RE: MCT INDUSTRIAL PARK (B18-D4). GRADING AND DRAINAGE PLAN
SUBMITTAL FOR GRADING PERMIT APPROVAL. ENGINEER'S STAMP DATED
JANUARY 31, 1997.

MCT INDUSTRIAL PARK
GRADING & DRAINAGE PLAN
D. MARK GOODWIN & ASSOCIATES, P.A.
CONSULTING ENGINEERS & SURVEYORS
P.O. BOX 90606
ALBUQUERQUE, NEW MEXICO 87199
(505) 345-2010

3-27-97
INTELIM
EROSION PROTECTION — TYPICAL DETAIL
NOT TO SCALE

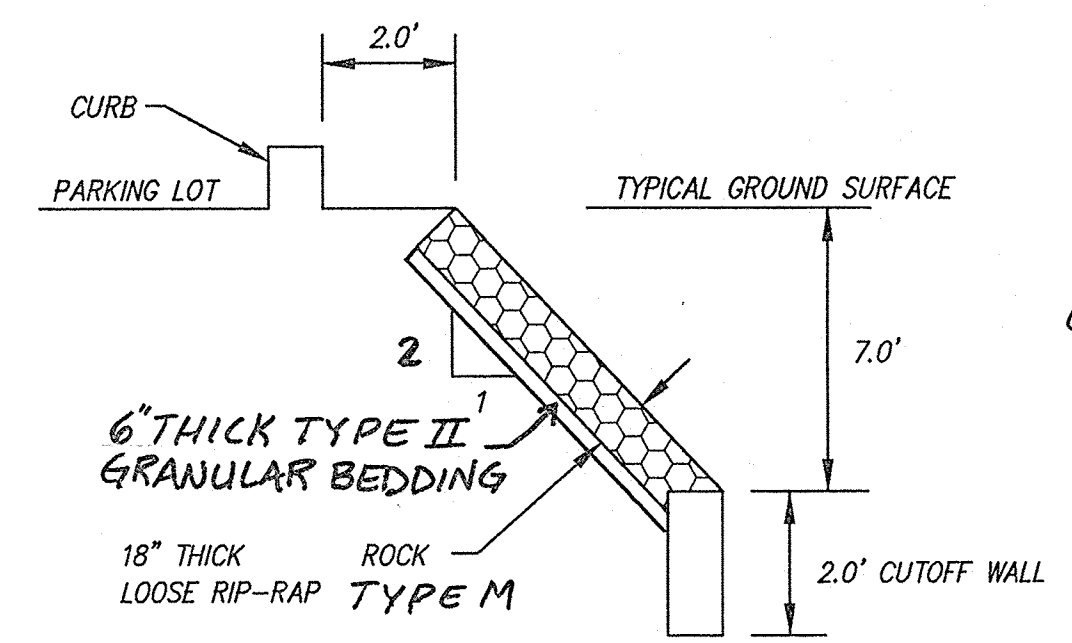
YTB PE 3-27-97
AMAFCA ✓ DATE
